Callaway Energy Center

ULNRC-06215

**DOCKET NUMBER 50-483
CALLAWAY PLANT UNIT 1
UNION ELECTRIC CO.
FACILITY OPERATING LICENSE NPF-30
REVISION OF TS 2.1.1.1 AND 5.6.5 TO REMOVE UNCERTAINTIES FROM THE DNBR
SAFETY LIMIT AND ADOPT APPROVED WCAP-14565-P-A METHODOLOGY**

Figure 4.4-3a
Measured Versus Predicted Critical Heat Flux – ABB-NV Correlation

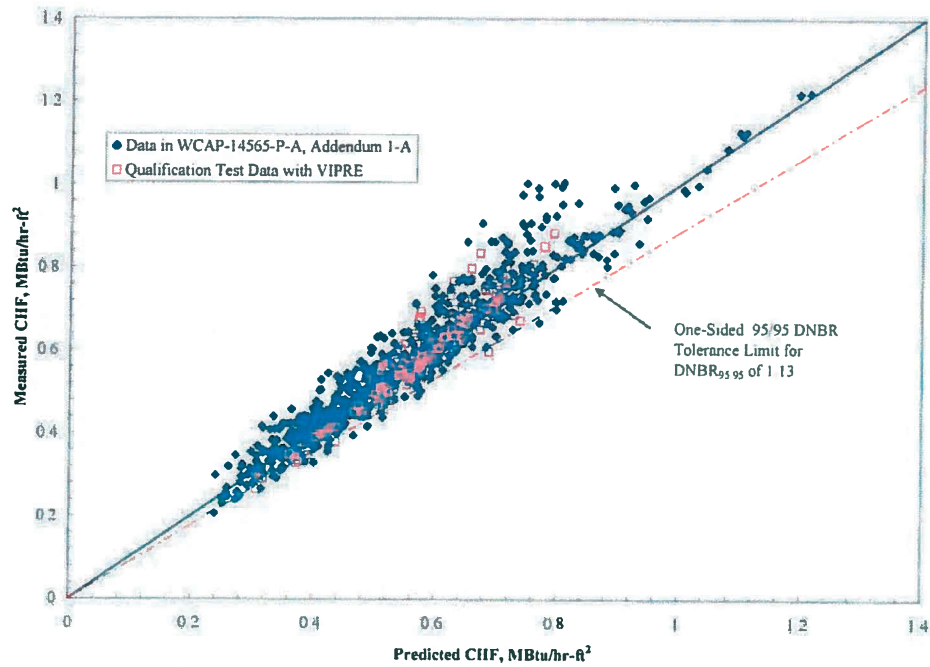
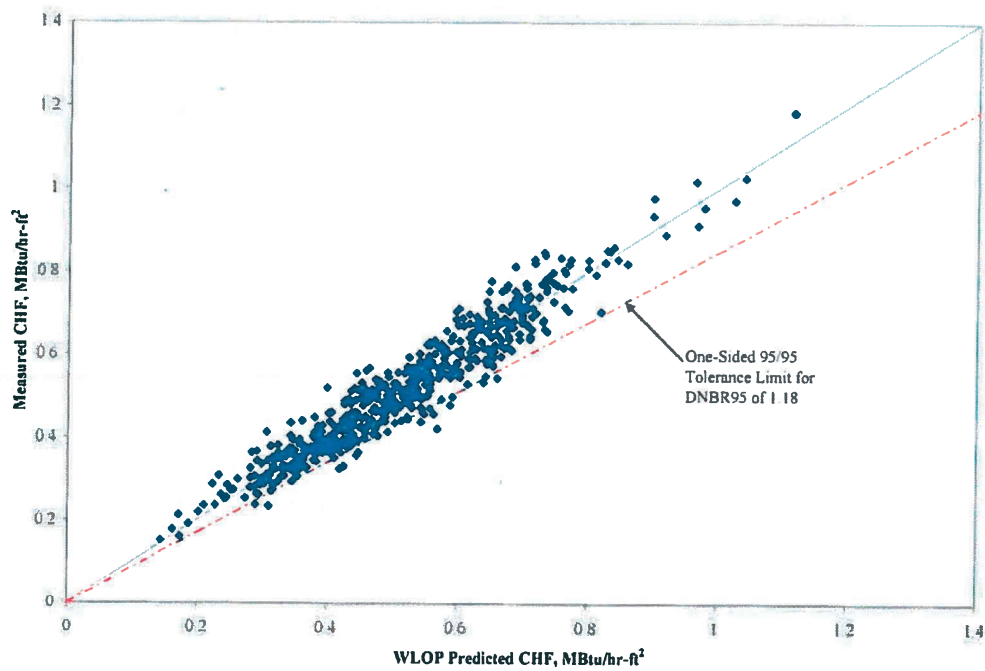
The WLOP correlation is a modified ABB-NV correlation specifically developed for low pressure conditions and extended flow range to cover low pressure/low flow conditions. Modifications to ABB-NV were made based on test data from rod bundles containing non-mixing vane grids. The WLOP correlation with a 95/95 DNBR limit has also been validated with test data from rod bundles containing mixing vane grids (Reference 93). The WLOP correlation with a 95/95 DNBR limit of 1.18 has also been validated with test data from rod bundles containing mixing vane grids (Reference 93). Figure 4.4-3b shows measured critical heat flux plotted against predicted heat flux using the WLOP correlation.
